Access Compliance Report

Public Rights-of-Way

Intersection ID: 27608	Main Street: NOLAND_WOODS_DR	Cross Street: PROVINCETOWNE_DR	Location: NE
ADA ID: E64339572BEE	Ramp Type: PerpDiag	Initial Pass/Fail: Fail	Overall Compliance: No
Codes/Mitigation Info/Possible Solution		Field Measurements/Component Compliance

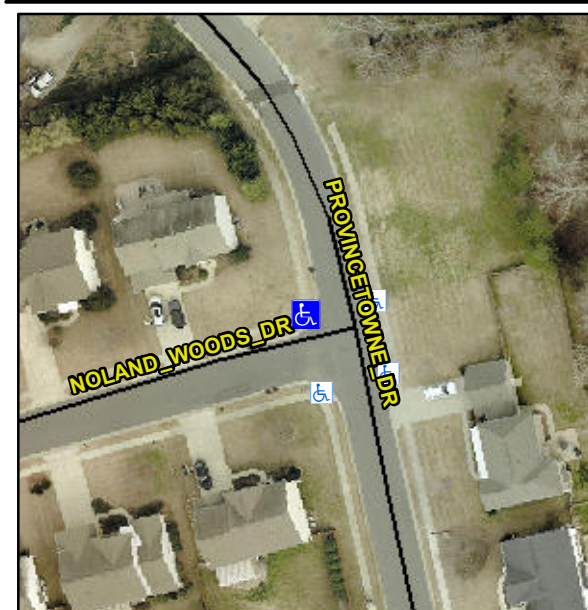
Not Found, R304.5.1, R304.5.3

Compliance	Description	Data	Compliance	Description	Data
N/A	Ramp Length (in)	93.0	Yes	Ramp Slope (%)	5.5
No	Ramp Width (in)	33.0	No	Ramp XSlope (%)	4.0
N/A	Flare Type LT	N/A	N/A	Flare Type RT	N/A
N/A	Flare Slope LT (%)	N/A	N/A	Flare Slope RT (%)	N/A
N/A	Flare Traversable LT?	N/A	N/A	Flare Traversable RT?	N/A
N/A	Landing Length (in)	N/A	N/A	DWS Provided?	N/A
N/A	Landing Width (in)	N/A	N/A	DWS Contrast?	N/A
N/A	Landing Slope (%)	N/A	N/A	DWS Length (in)	N/A
N/A	Landing X Slope (%)	N/A	N/A	DWS Full Width?	N/A
N/A	Landing Curb? (Y/N)	N/A	N/A	DWS Offset (in)	N/A
N/A	Shared Landing?	N/A			
N/A	Gutter Ponding?	N/A	N/A	Gutter Slope (%)	N/A
N/A	Gutter Lip Ht (in)	N/A	N/A	Gutter X Slope (%)	N/A
N/A	Painted X Walk1?	No	N/A	Painted X Walk2?	No
	X Walk 1 Direction	To S		X Walk 2 Direction	To E
N/A	X Walk 1 Width (in)	N/A	N/A	X Walk 2 Width (in)	N/A
	X Walk 1 Slope (%)	5.0		X Walk 2 Slope (%)	3.2
	X Walk 1 X Slope (%)	1.7		X Walk 2 X Slope (%)	2.8

Remove & Replace Curb Ramp With Two New Directional Ramps or Equivalent.
